GENERAL APPLICATION

Location Address: 5730 JOHNSON STREET, HOLLYWOOD, FLORIDA

QUADS PLAZA
PROP. 2 STORY MULTIFUSE BUILD.
AT
5730 JOHNSON STREET
HOLLYWOOD, FLORIDA

DATE: 09/10/2022
DRAWN BY DM
PROJECT NO. 2022-00129
REVISED BY MN
SHEET NO. L-1

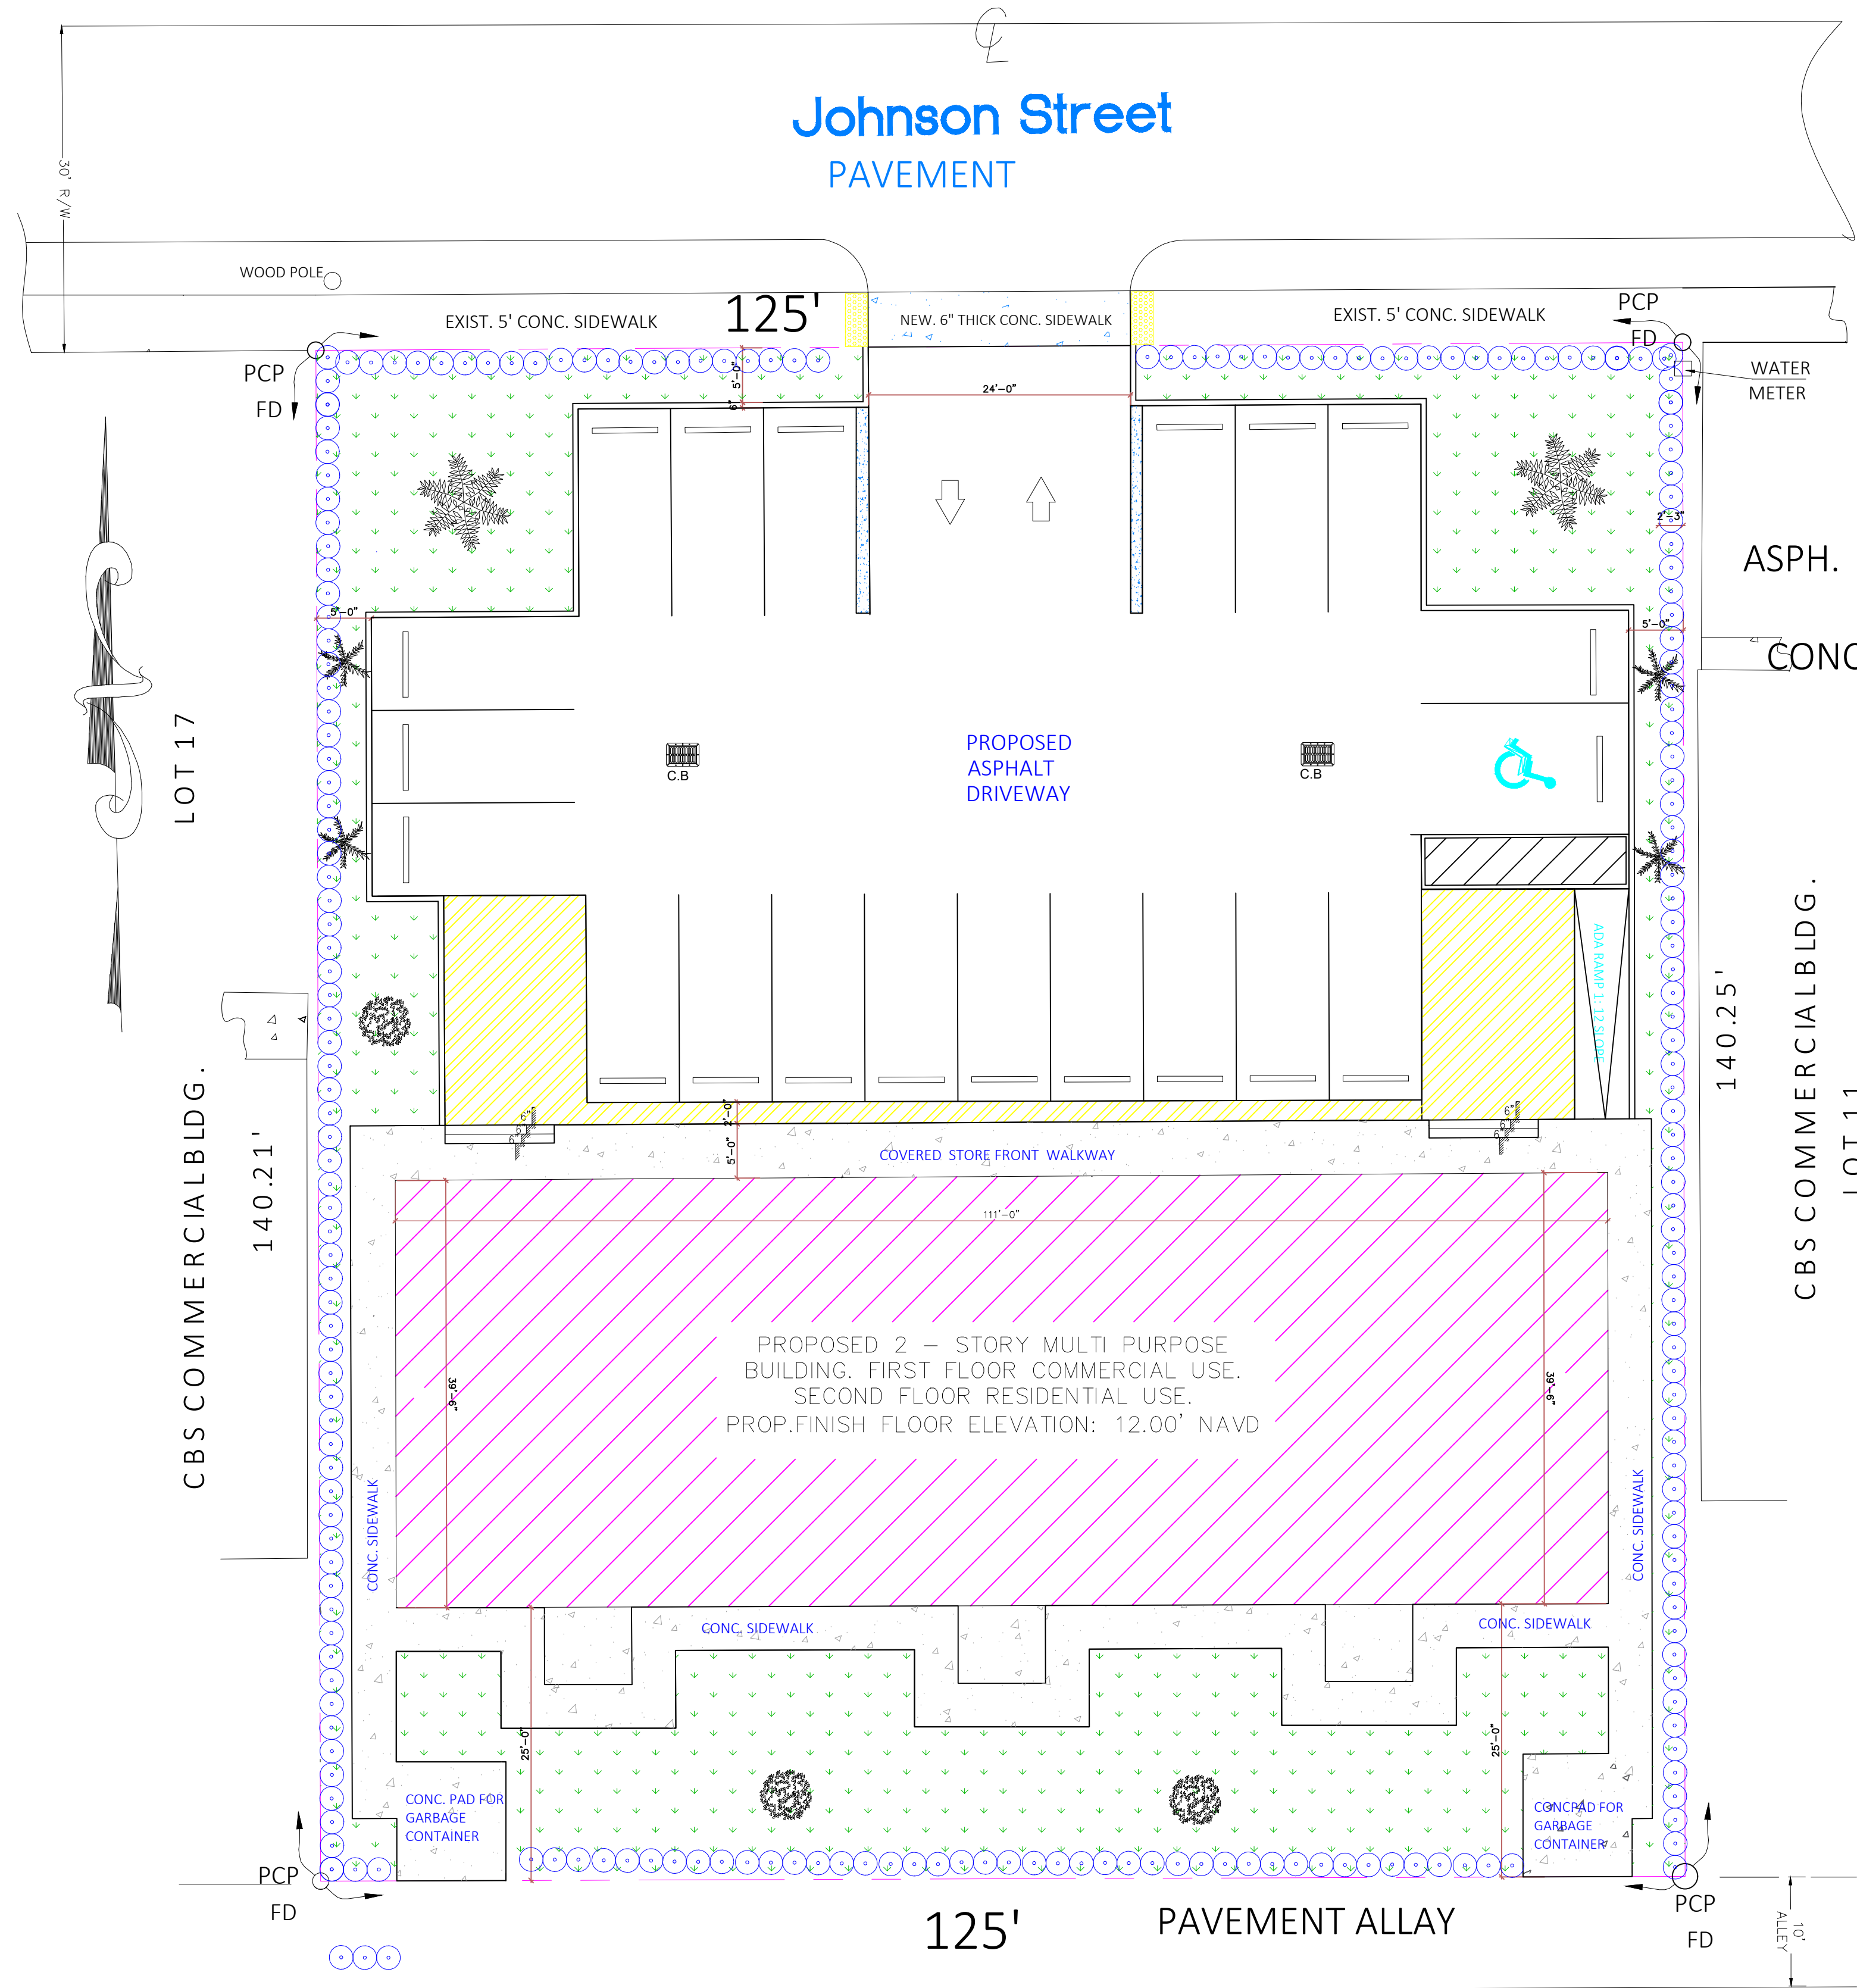
6. Native plant requirements; 60% trees, 50% shrubs – Sec. 3.4.

7. Label all sides of property weather there are 'Existing Overhead Powerlines' or 'No Overhead Powerlines'. Provide FPL approved trees for planting under powerlines.

Response: Please see the landscape plan L-1.

Response: Please see the landscape plan L-1.
